Re: Petition No. 1575: Salisbury Substation Transformer Replacement Project

Response to CSC-01 Interrogatories dated June 20, 2023

Set 01 – Questions 1-23

Attachment 12.1, Drawing 22203-11102, provides the details of the proposed firewall and its dimensions. The firewall plan and sections are highlighted in yellow.

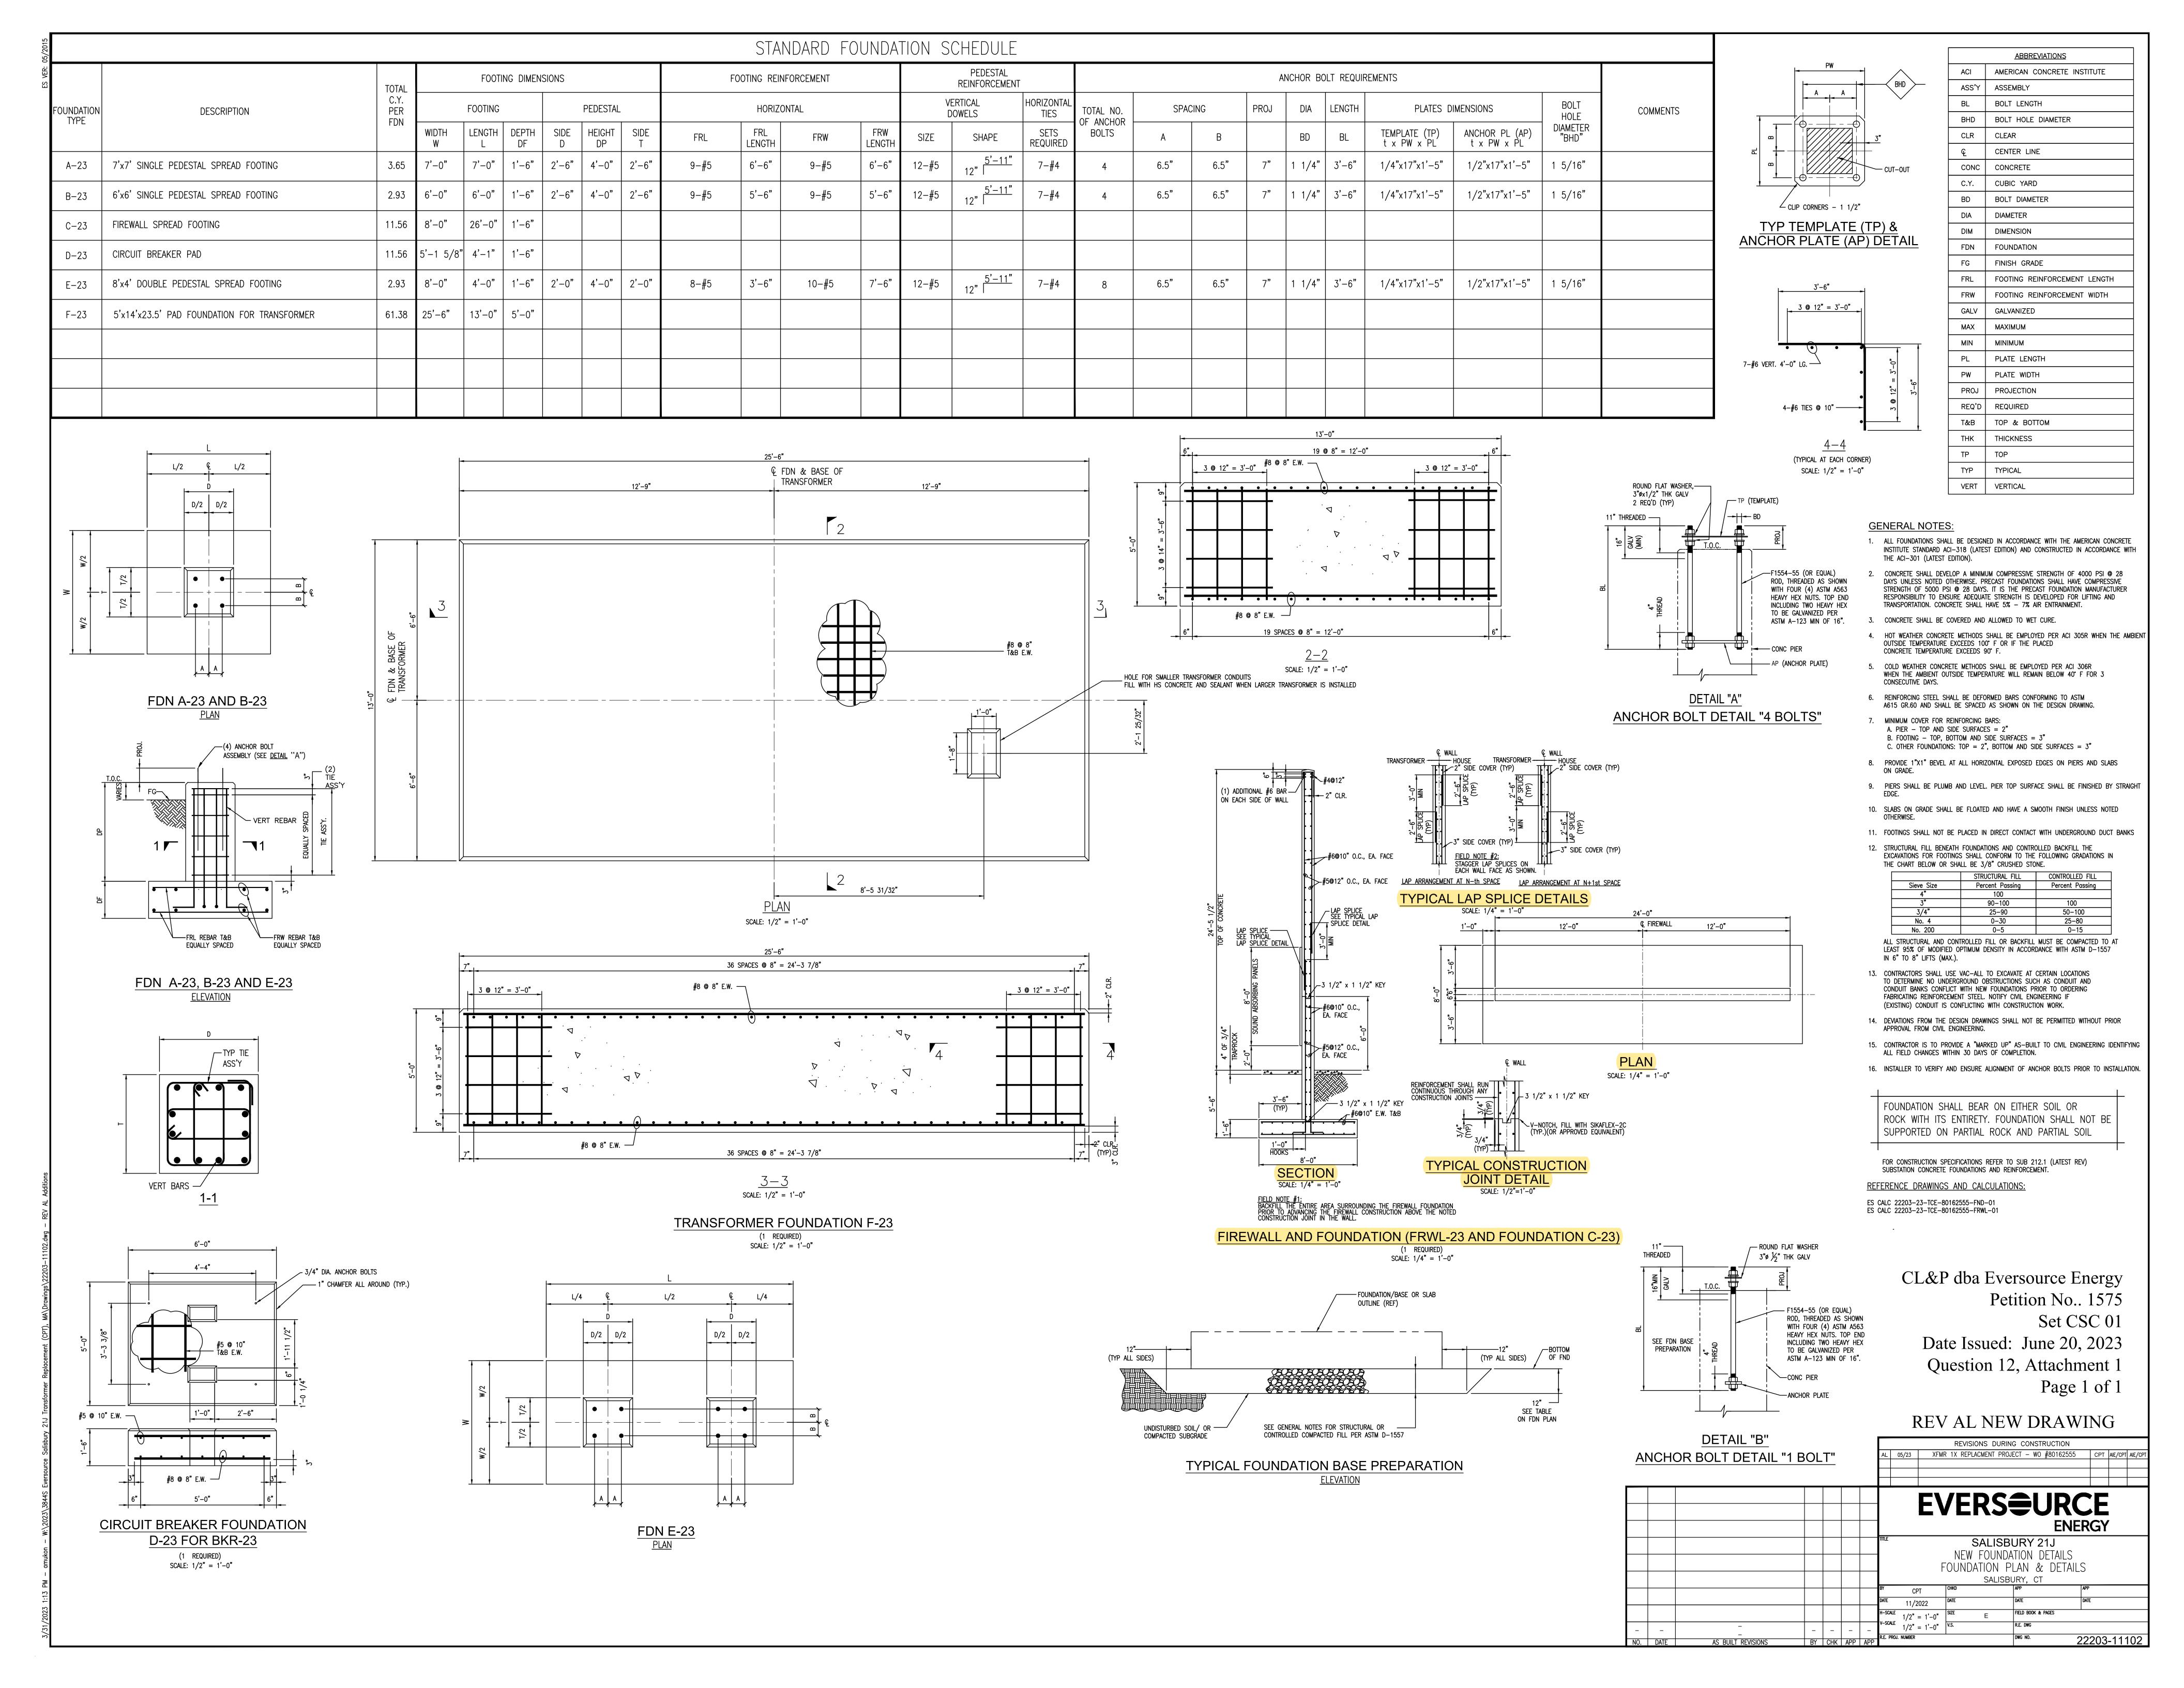
Please provide a drawing of the proposed firewall and its dimensions.
